FORM APPROVED
OMB NO. 1004-0135
Expires: July 31, 2010**SUNDRY NOTICES AND REPORTS ON WELLS**
*Do not use this form for proposals to drill or to re-enter an abandoned well. Use form 3160-3 (APD) for such proposals.*5. Lease Serial No.
NMNM55149

8. Well Name and No.
CORBIN SOUTH FEDERAL COM 22. Name of Operator
OXY USA INCORPORATEDContact: JENNIFER A DUARTE
E-Mail: jennifer_duarte@oxy.com9. API Well No.
30-025-41424-00-S1

OXY USA INC respectfully request permission to plugback and recomplete in the Bone Spring formation. Please see the proposed procedure and the attached wellbore diagrams for your use and review.

Permanent Abandonment of Production Zone Conditions of Approval

WELLBORE DIAGRAM

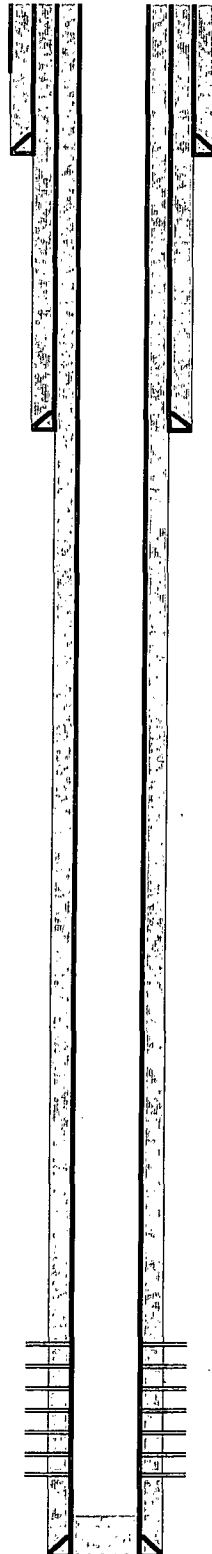
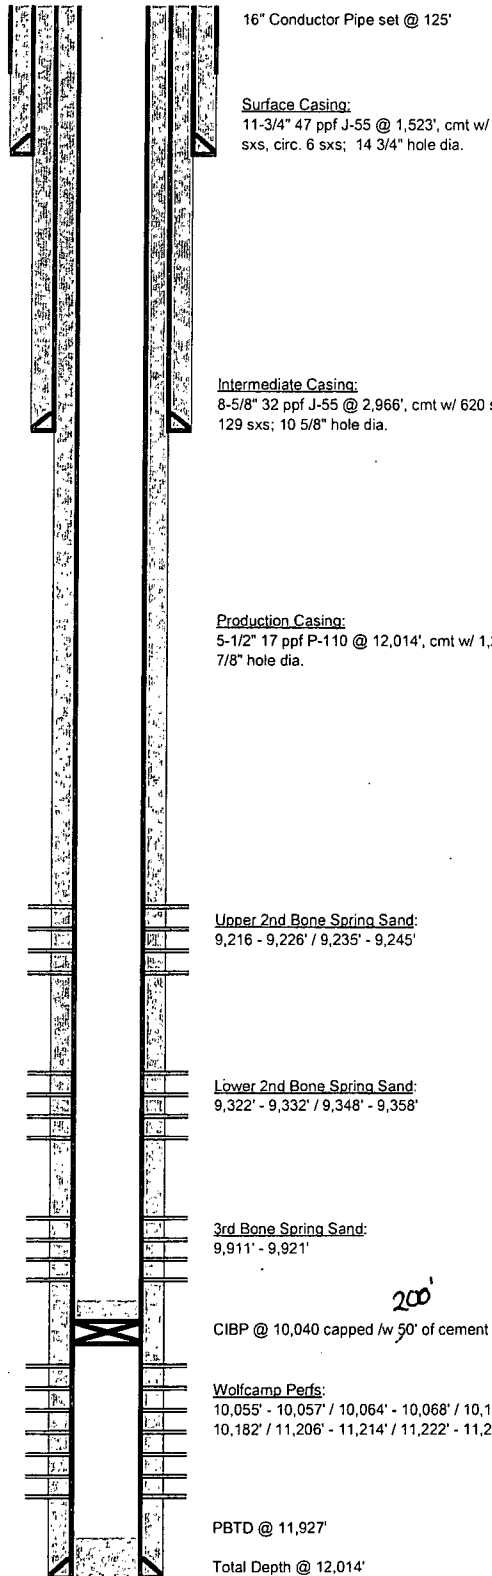
- 200'
1. Set CIBP @ 10,040' and cap /w 50' cement.
 2. Perforate, stimulate and test 3rd Bone Spring Sand from 9,906' to 9,931'.
 3. Set RBP @ 9,890' and cap /w 2 sxs of sand.
 4. Perforate, stimulate and test 2nd Bone Spring Sand from 9,322' to 9,362'.
 5. Set RBP @ 9,300' and cap /w 2 sxs of sand.
 6. Perforate, stimulate and test 2nd Bone Spring Sand from 9,209' to 9,253'.
 7. Set RBP @ 8,500' and cap /w 2 sxs of sand.
 8. Perforate, stimulate and test 1st Bone Spring Carbonate from 8,150' to 8,300'.

9. Set RBP @ 8,000? and cap /w 2 sxs of sand.
10. Perforate, stimulate and test 1st Bone Spring Carbonate from 7,775? to 7,858?.
11. Retrieve RBP?s @ 8,000?, 8,500?, 9,300?, and 9,890?.
12. RIH /w production equipment.

In lieu of a cement plug across perforations in a cased hole (not for any other plugs), a bridge plug set within 50 feet to 100 feet above the perforations shall be capped with 25 sacks of cement. If a bailer is used to cap this plug, 35 feet of cement shall be sufficient. **Before pumping or bailing cement on top of CIBP, tag will be required to verify depth.**

Unless otherwise specified in the approved procedure, the cement plug shall consist of either **Neat Class "C"**, for up to 7,500 feet of depth or **Neat Class "H"**, for deeper than 7,500 feet plugs.
